RE: Minor PDD Modification Request and ADR Re-Approval at 6270 Limestone Lane

LIMESTONE RIDGE

POOL PLAZA

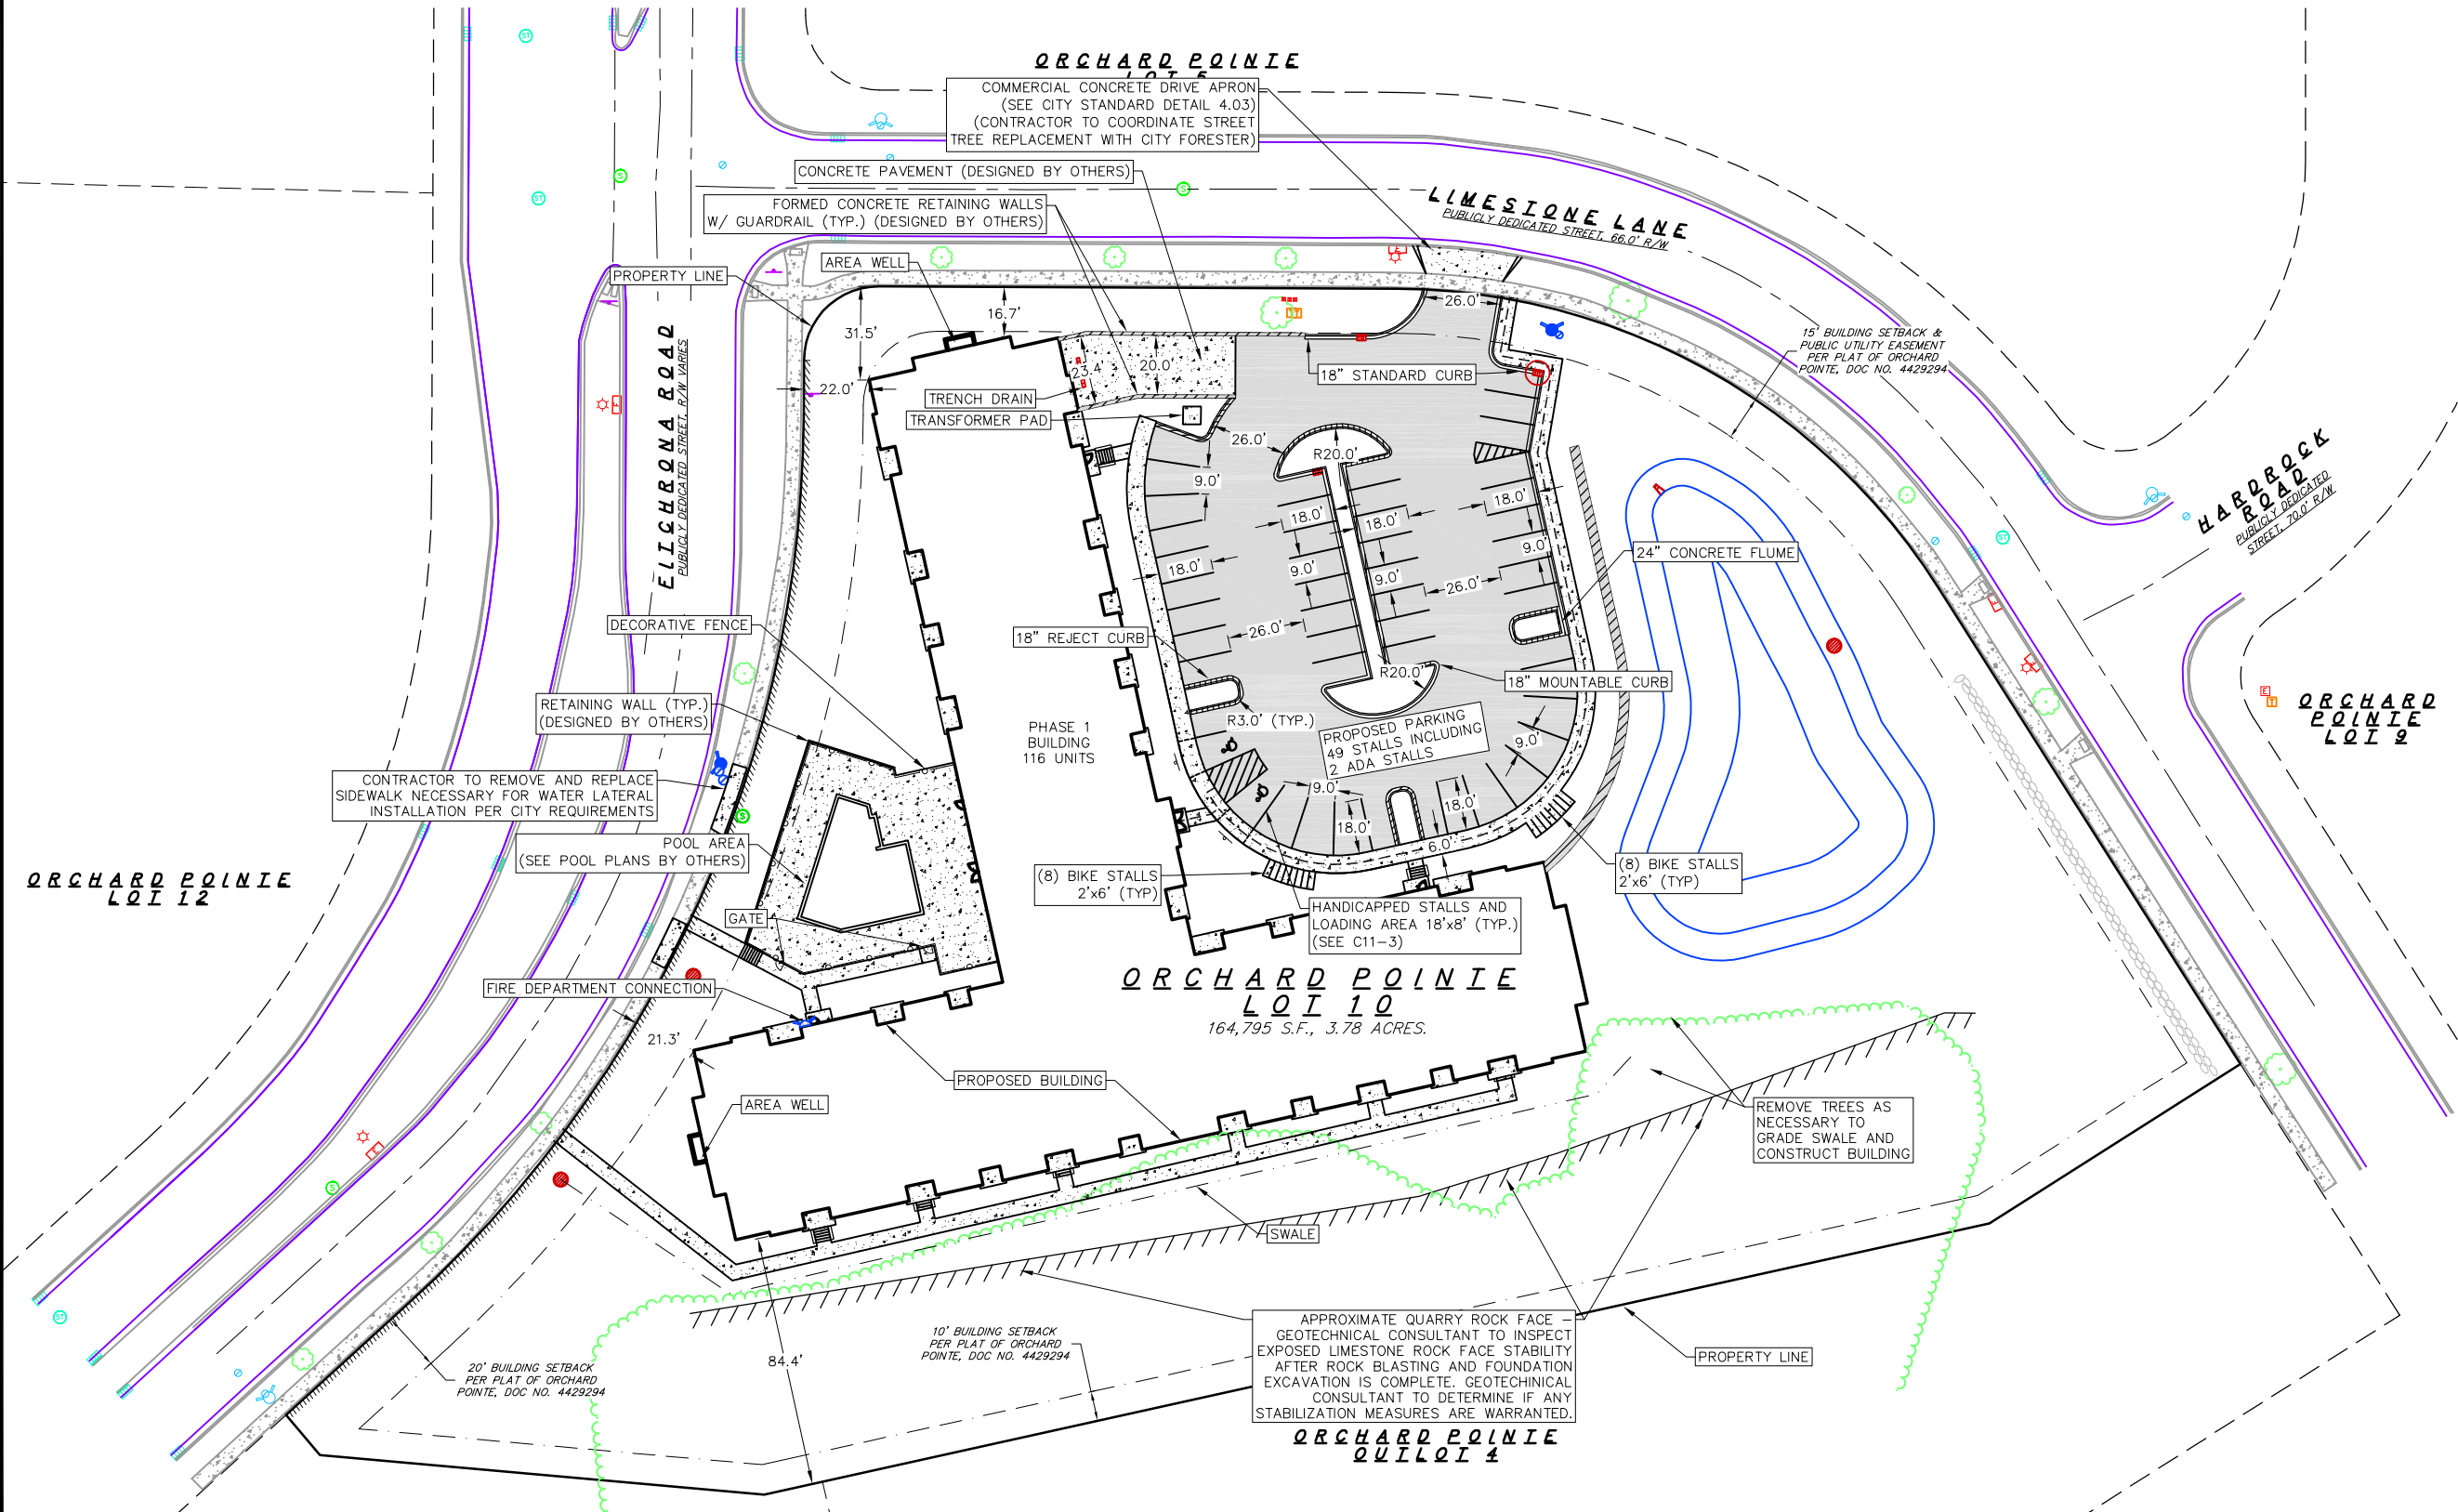
Please accept this letter from JT Klein Company Inc. as our request to make minor modifications to our previously approved PDD and ADR applications at 6270 Limestone Lane. JT Klein Company is removing the playground area and replacing it with an approximately 1,103sqft pool and 3,281sqft patio area. As proposed this iteration will encroach slightly with a small portion of the patio and landscaping within the setback, however all building structure will be outside the setback area.
